ADDENDUM 02

Project Name: South King Fire Administrative Building Improvements
Owner: South King Fire
Issued by: Lauren Rock, Weinstein A+U
Issue Date: August 7, 2025

C1.1

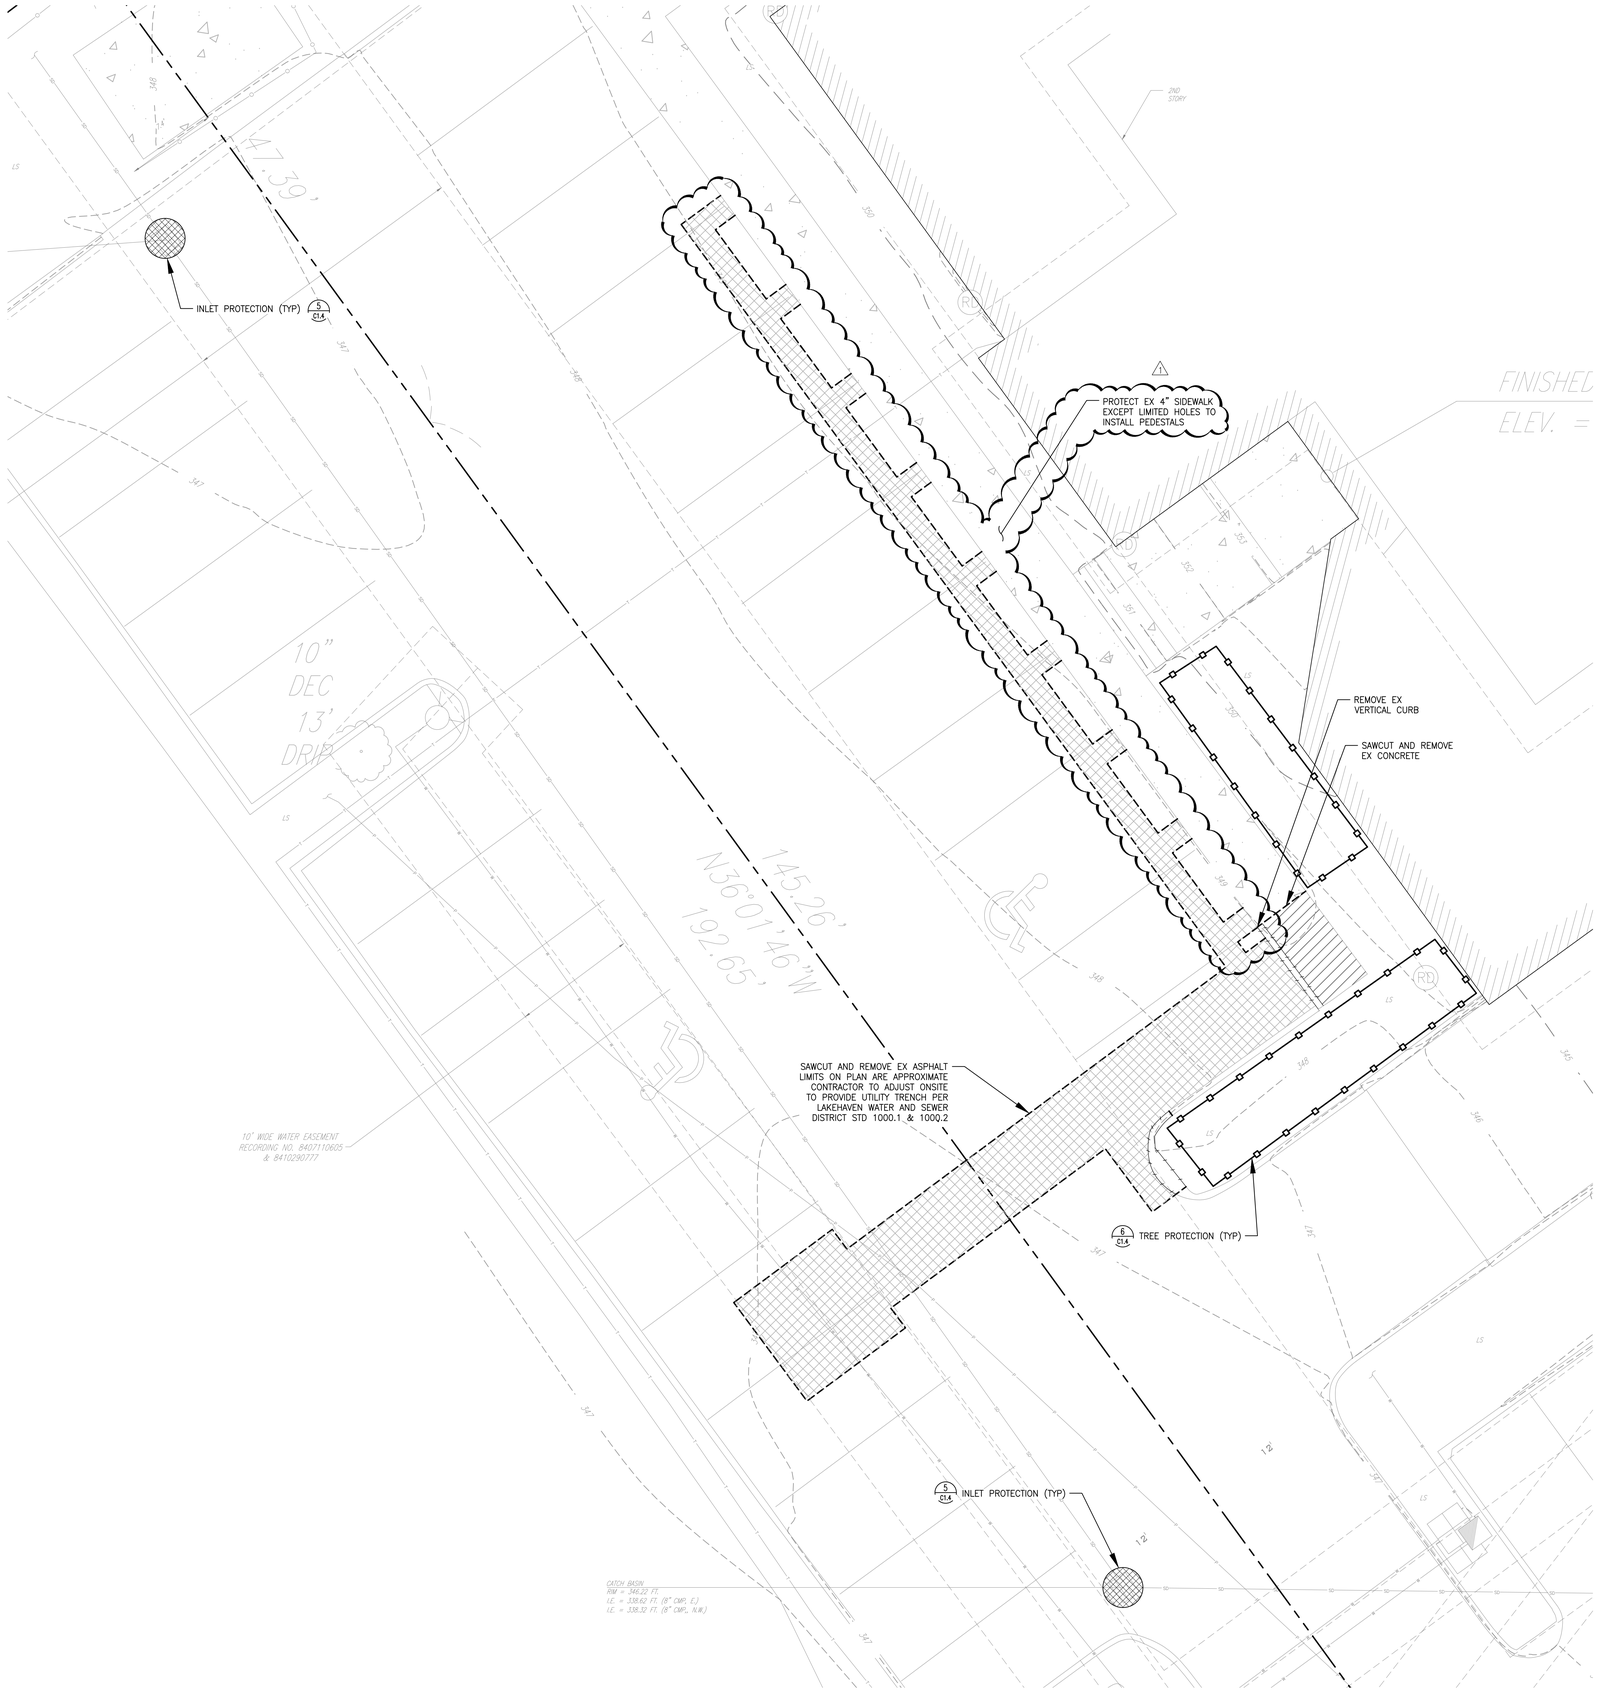
C1.1	Changed limits of asphalt removal to match Paving Plans.
C1.3	Added pavement removal for electrical trench and electrical routing.
C2.1	Changed paving hatches for clarity.
C2.3	Added pavement removal for electrical trench and electrical routing. Added electrical conduit trench. Added wheel stops.
C2.4	Added pavement removal for electrical trench and electrical routing. Added electrical conduit trench. Added wheel stops. Added CSTC as a subgrade option to asphalt pavement detail.
C3.1	Added routing of fire water line.
A001	Indicated locations of shore power pedestals and wheel stops.
A002	Indicated locations of wheel stops.

C1.3

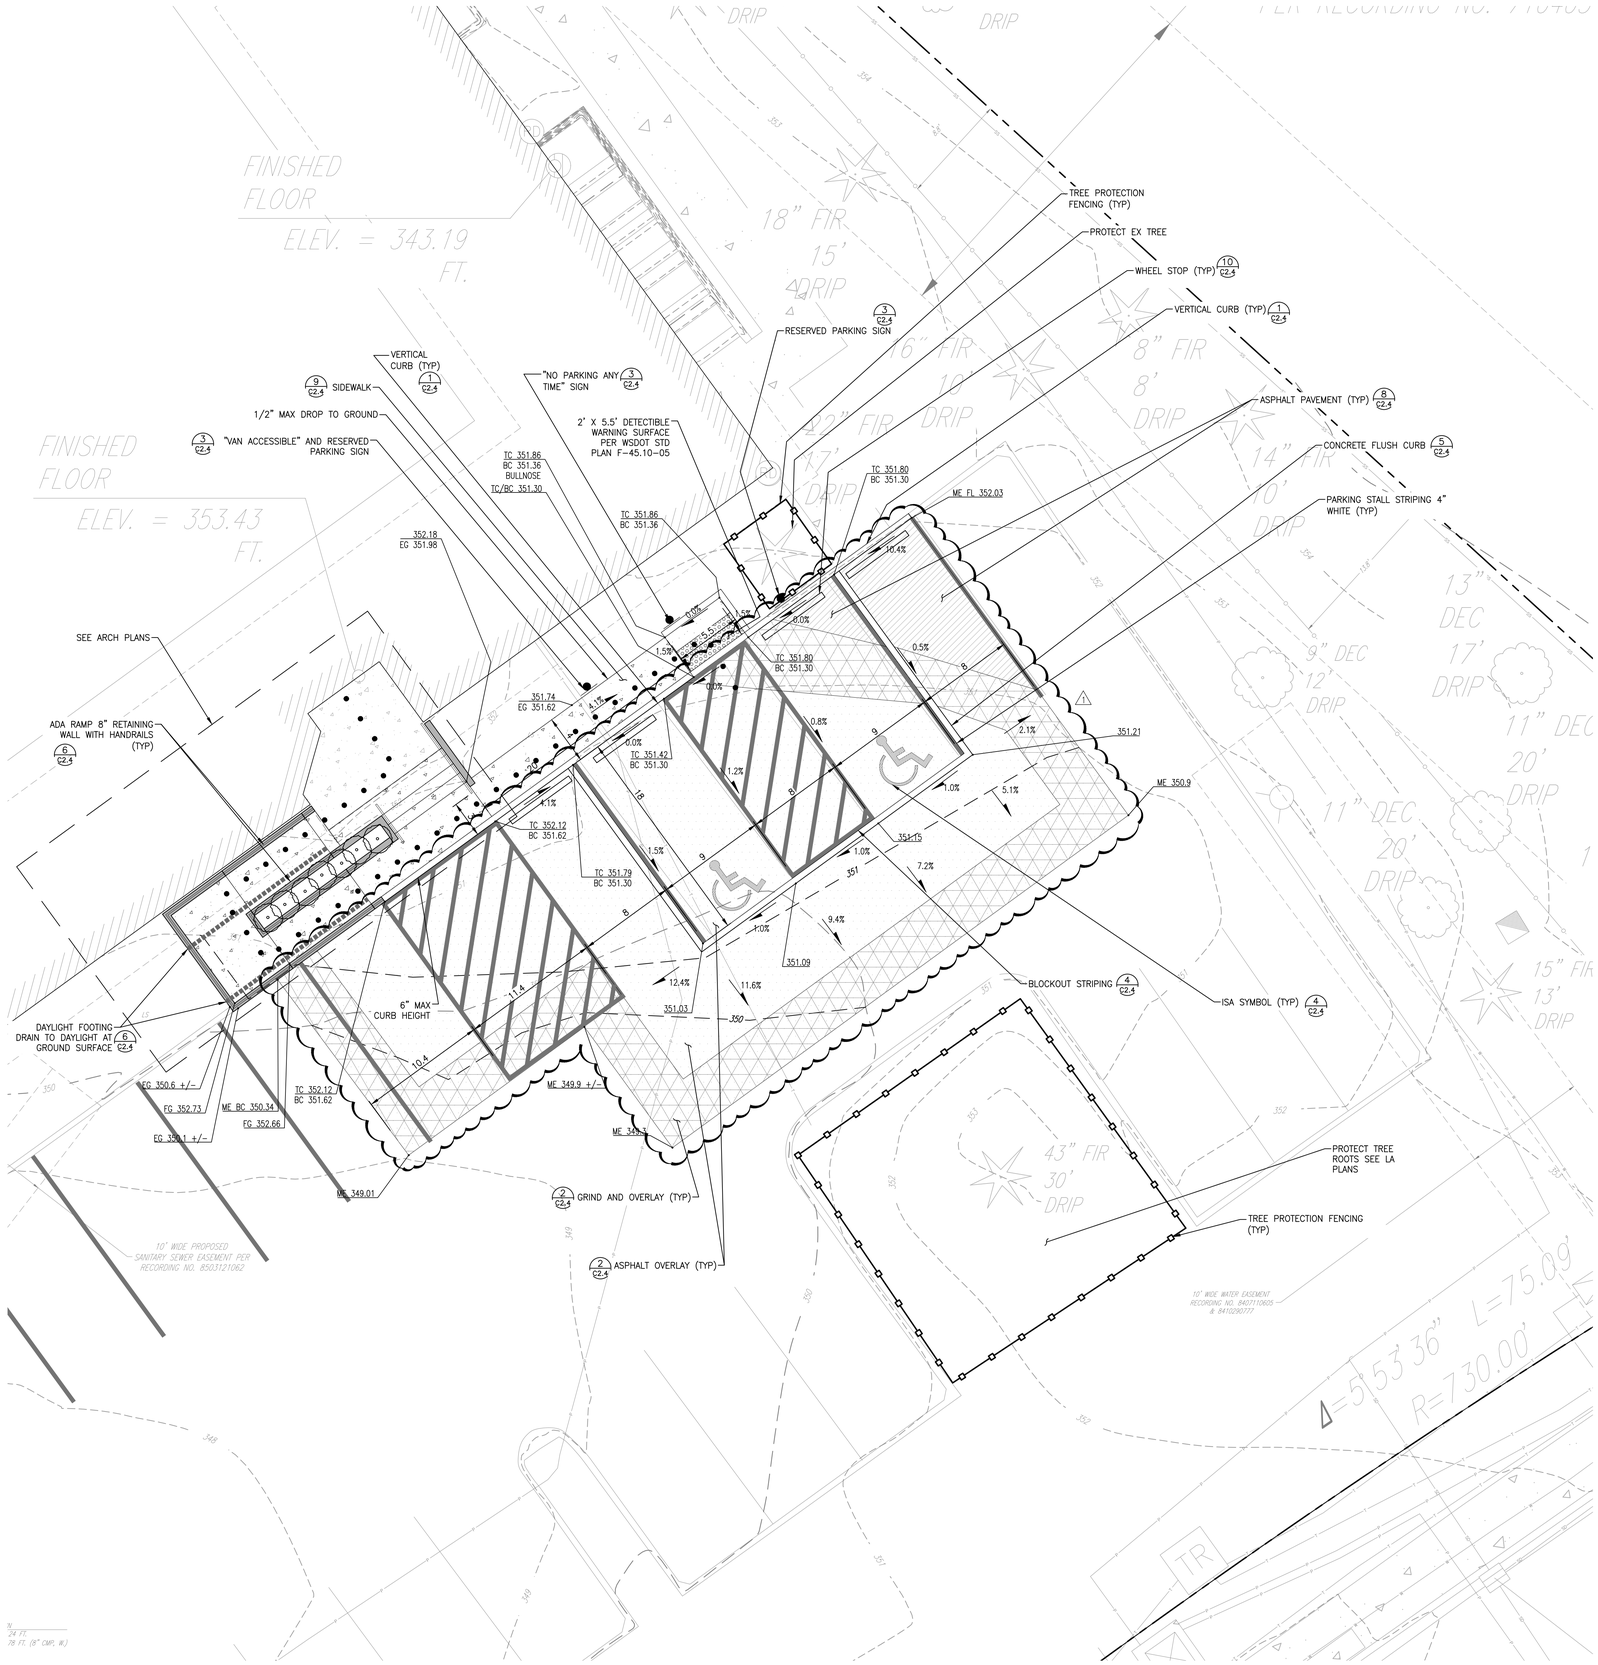
02.	Question: The drawings show shore power in the sidewalk. Are we to demo the sidewalk and replace in order to install? Answer: See revised sheets C1.3 and C2.3.

05.	Question: Regarding the new 6” fire line water tap location, sheet C1.3 site demolition location for the new underground piping. Answer: Approximate plan limits for site demolition are shown in hatched area on C1.3.

NTS **ELECTRICAL CONDUIT TRENCH** 11

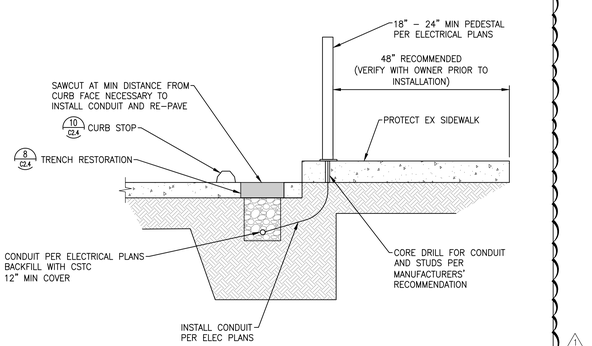
03.	Question: Do there need to be wheel stops added to protect the shore power? Answer: See revised sheets C2.3 and C2.4 for wheel stop locations and detail.

04.	Question: Need a routing plan on how to get power to this location. Are we cutting and patching asphalt? If so, please provide a detail. Answer: See revised sheets C2.3 and C2.4.

C3.1

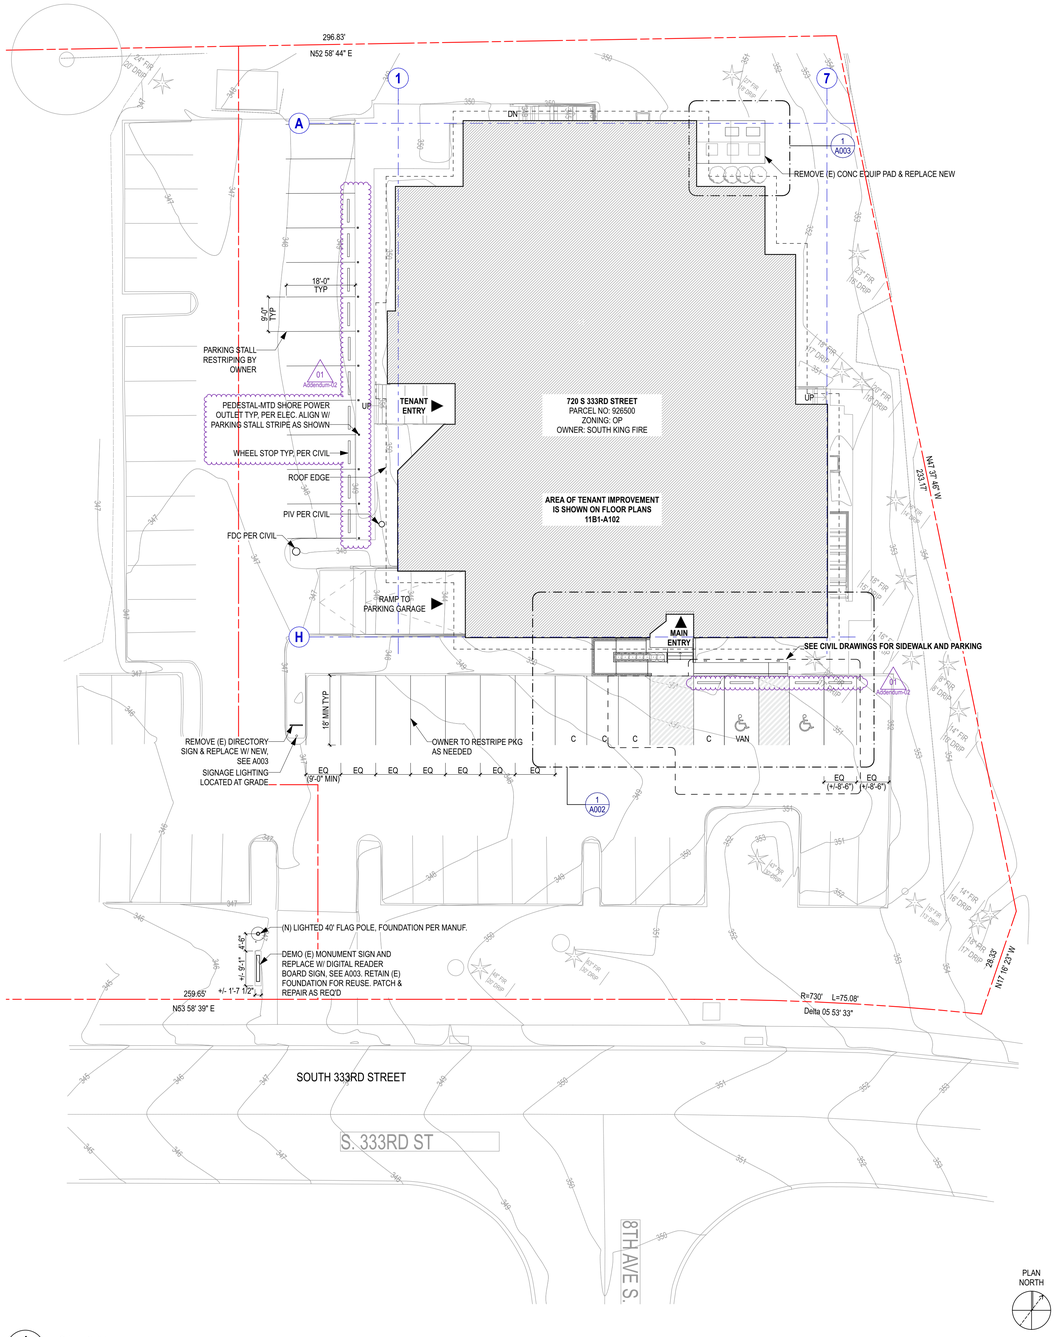
06.	Question: Sheet 2.3 site underground piping location for the new fire line. Answer: Exact location of new fire water line to be means and methods, within plan limits shown on revised sheet C3.1. Piping to meet requirements of the AHJ.

07.	Sheet C3.1 location of the new fire line piping where it enters the building. Answer: See C3.1 and F100 for approximate location of new fire line piping. Exact point of entry to be coordinated on site during construction phase.

10.	Question: Sheet F100 shows the new sprinkler riser room and riser piping location with exterior underground fire line in conflict with the C drawings tap and piping locations. Answer: Approximate piping routing indicated on revised sheet C3.1. Exact point of entry to be coordinated on site during construction phase.
